RE: Public Comment Response to email dated 7/2/2024

From: leasing avellinoapartments.com <leasing@avellinoapartments.com>
Sent: Wednesday, June 26, 2024 3:59 PM
To: Ryan Harriman
Subject: RE: 2900 78th Ave SE File # DSR24-010 & SEP24-009

Subject: Totally Against DSR22-014 Baskin Robbins Proposed 10-unit building

Figure 2 — Retail Use Required Adjacent To Street Frontages

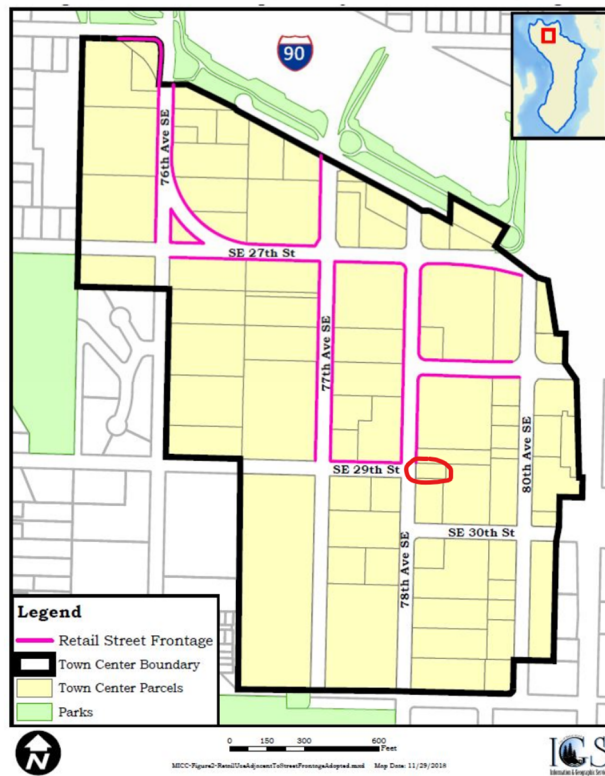
I am responding to the Public Notice of Application. First of all, I am sorry, but this section was never supposed to be residential only, it was supposed to be commercial as it is in the Town Center core, is it not?

I don't think they realize when they state: the proposed development provides stacked **multi-family residences** with primary pedestrian and vehicular access from 78th Ave SE." It is not 'multi-family' And it has where **RETAIL IS REQUIRED**, but the proposed building is not offering any retail. See map below:

- Per MICC 19.11.020 Land Uses, residential uses are permitted in the TC-4 zone. At the time this project was vested under the MICC, retail frontage was not required for any parcels south of the Avellino Apartments (2836 78th Ave SE). Please refer which reflects the applicable MICC regulations at the time of vesting. The Baskin-Robbins site is circled in red, illustrating that this site along with all other sites south along 78th Ave SE was not subject to retail frontage requirements.

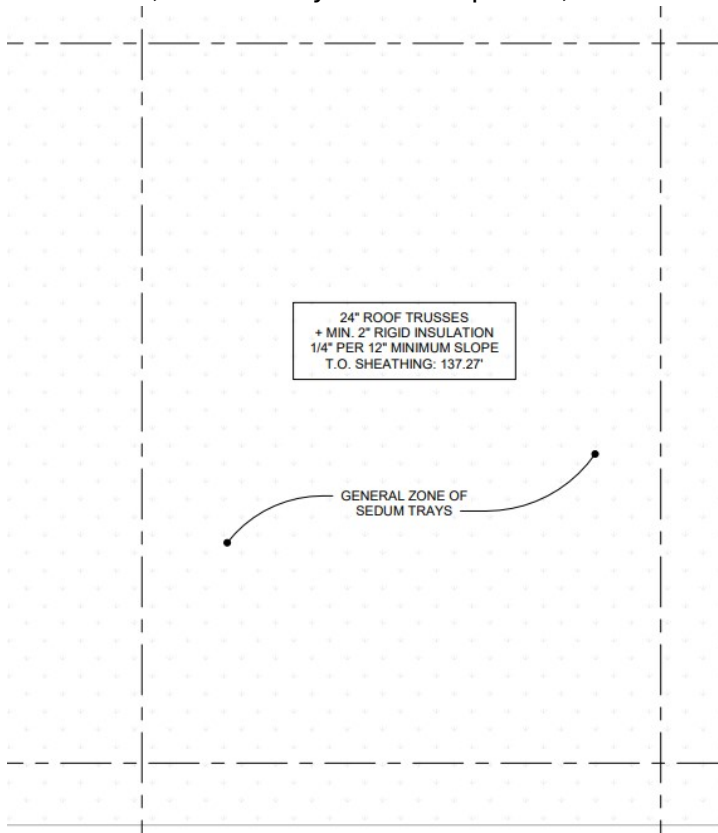
It says that 3,250 sf of sedum trays on the roof, but if you look at the plans on page 7, it does not show 3,250 sf of sedum trays, it shows a portion. And are you trying to say, that they can go across the road, buy a few trays of sedum and put them on the roof, and that is sufficient?

If you look at the plans, it has a section of the roof as for the sedum trays on a portion and not even on the whole roof, I doubt very much it equals 3,250 sf of roof space?
